FACILITY: HOPE CREEK GENERATING STATION

SUBJECT: SUMMARY OF INSTRUMENTATION AND CONTROL SYSTEMS BRANCH (ICSB)
MEETING

SUMMARY OF
HOPE CREEK OL REVIEW STATUS FOR CHAPTER 7
(INSTRUMENTATION & CONTROLS)
AGENDA ITEMS

FIGURE 421.23-1 INSTRUMENT LINE BREAK ANALYSES, BOC; NO HPCI; RCIC AVAILABLE WITH ARI

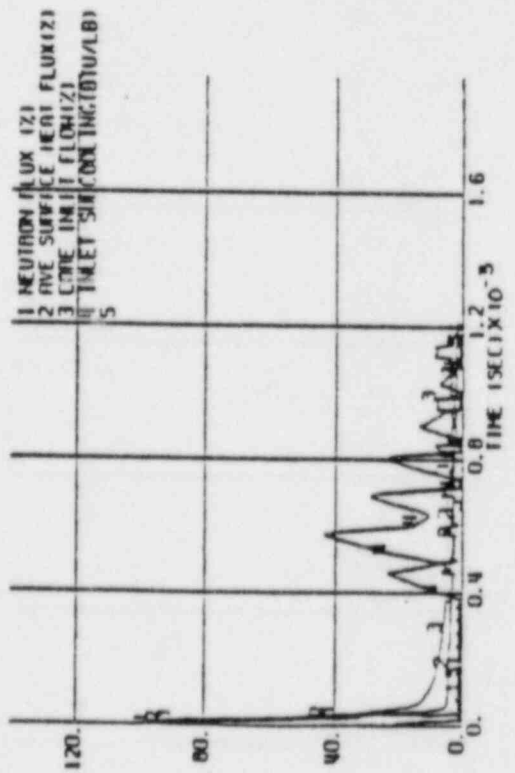
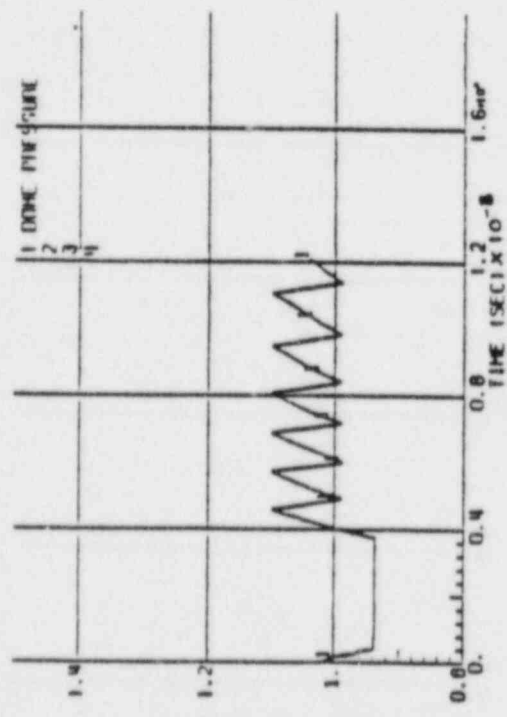
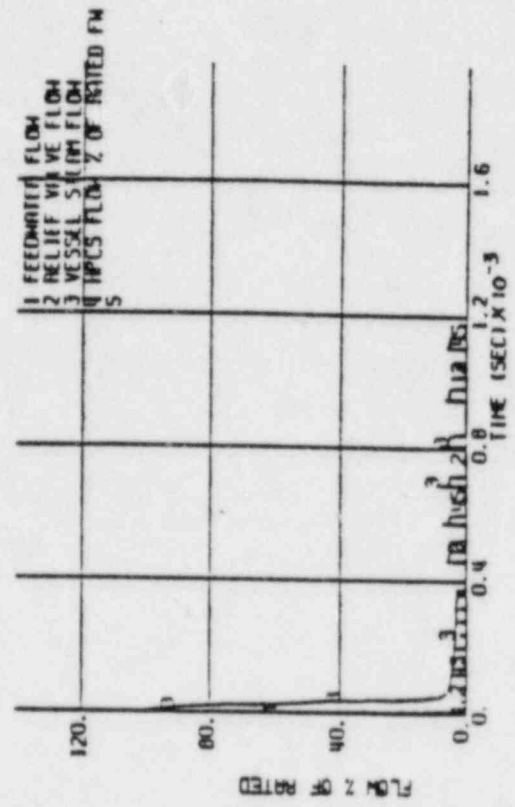
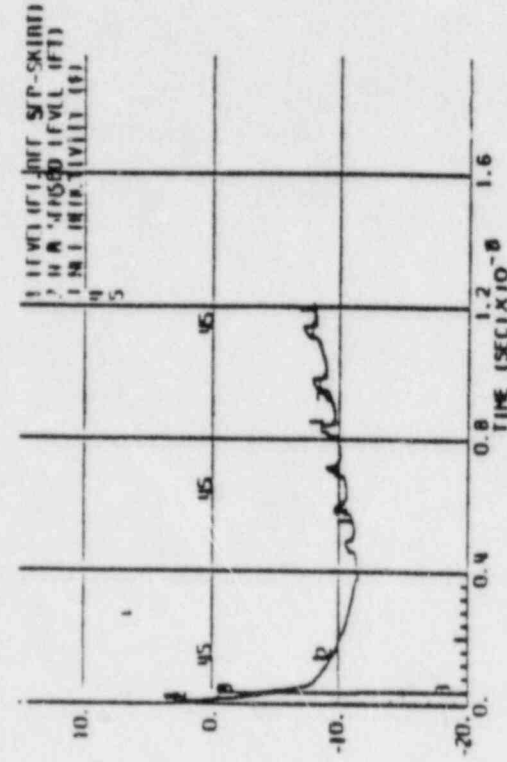
The case with the EOC void-reactivity coefficient showed that the minimum water level would be between level 1 and level 2. Figures 421.23-1 and 421.23-2 show the REDY plots for the cases with the BOC void-reactivity coefficient and the EOC void-reactivity coefficient, respectively. The case with the BOC void-reactivity coefficient showed that the minimum water level would be below level 1 outside the shroud and would trigger the closure of the MSIVs.

Figure 421.23-3

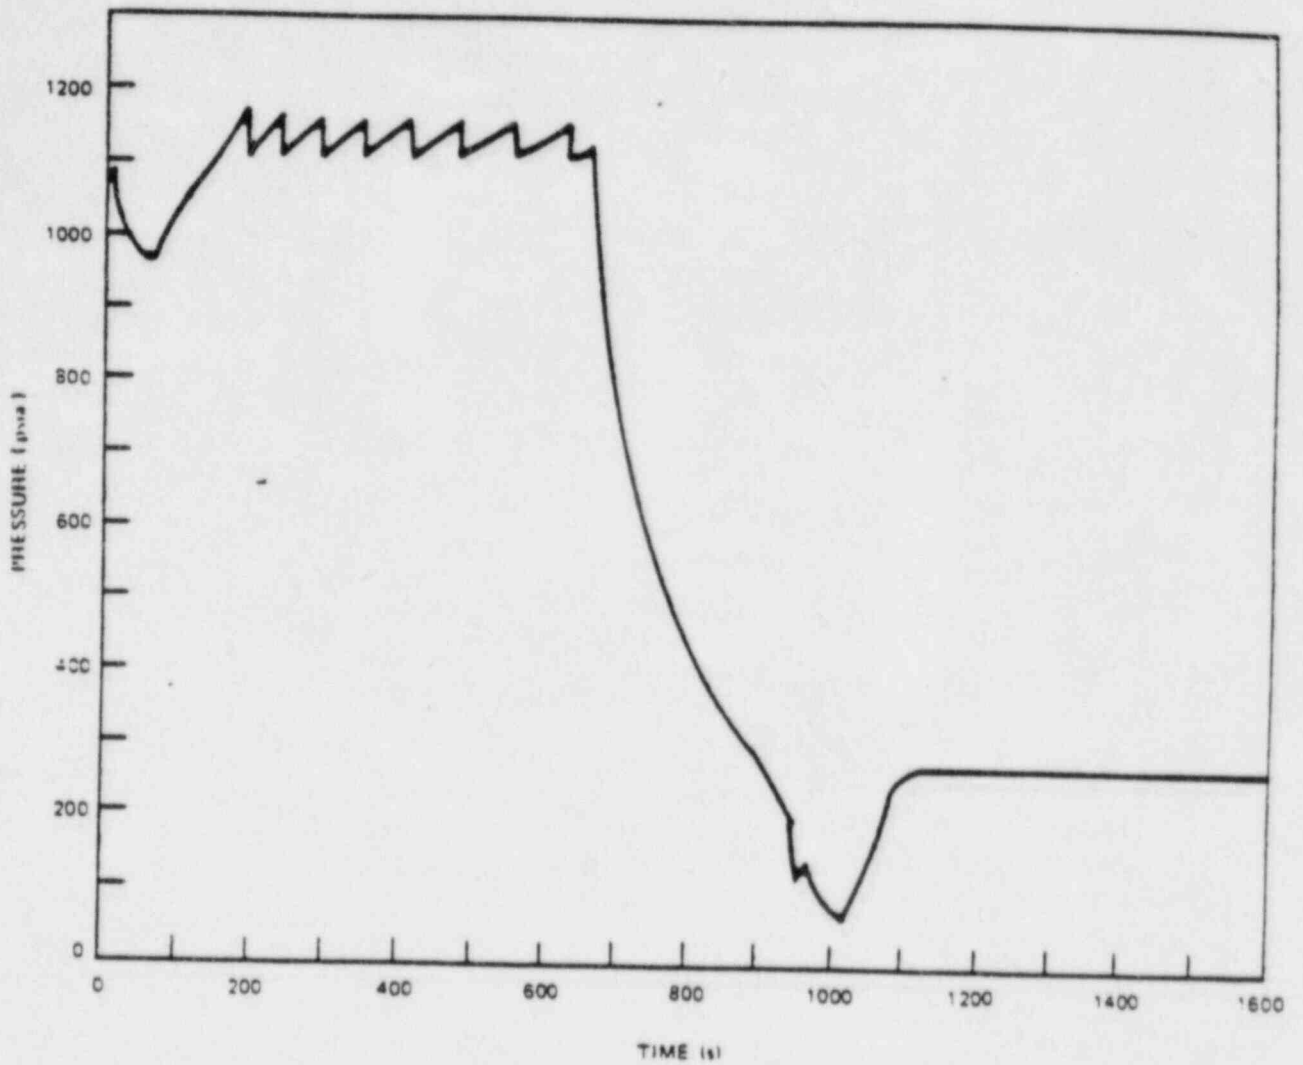
Figures 421.23-3 through 421.23-5 show the system pressure, water level inside the shroud, and peak cladding temperature (PCT), respectively, calculated from the core-heatup analysis. The minimum water level in the core would be 2.5 feet below the top of the active fuel (inside the shroud). This uncover level would result in a PCT of 450°F. Since this PCT is less than the initial cladding temperature of 644°F and well below the 2200°F limit, these results are acceptable from an ECCS viewpoint.

FIGURE 4-1.23-6 INSTRUMENT LINE BREAK ANALYTIC DATA, NO DATA NOT AVAILABLE WITH AHT

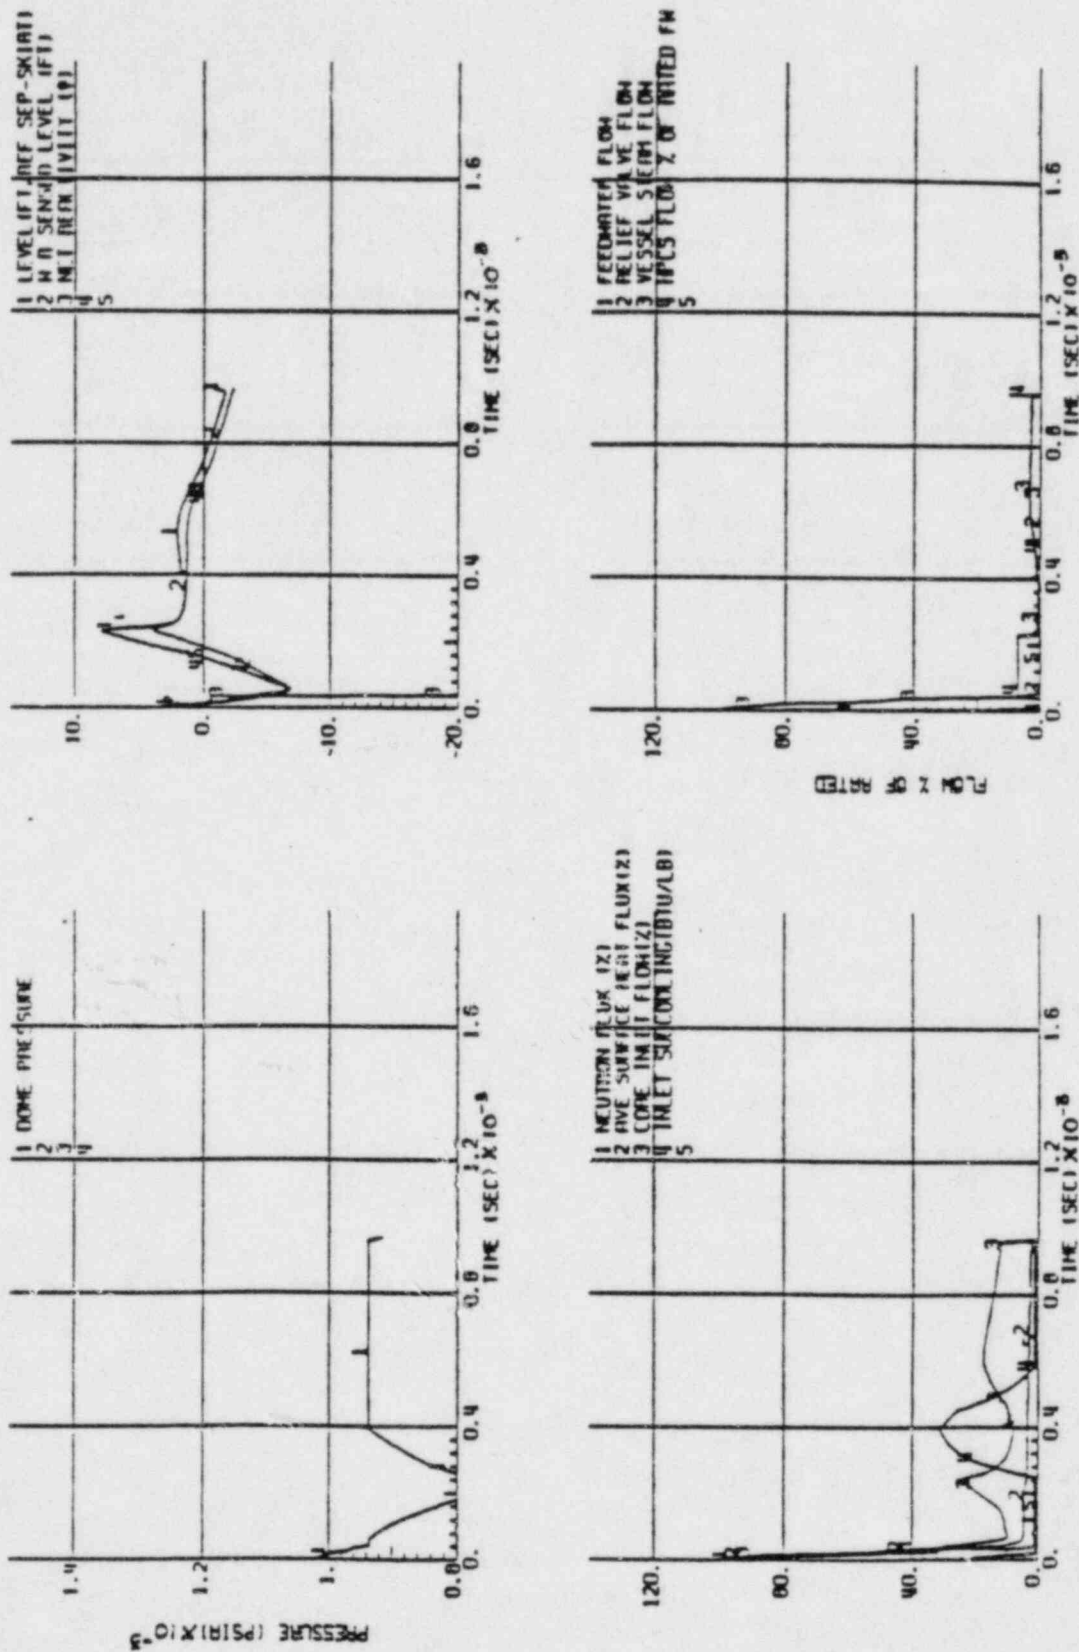
Figure 421.23-6 shows the REDY plot for this case. It can be seen that the minimum water level outside the shroud would be about 10 feet above the top of the active fuel. No core uncover was found.

Handwritten note:
Shows 2.5 feet above
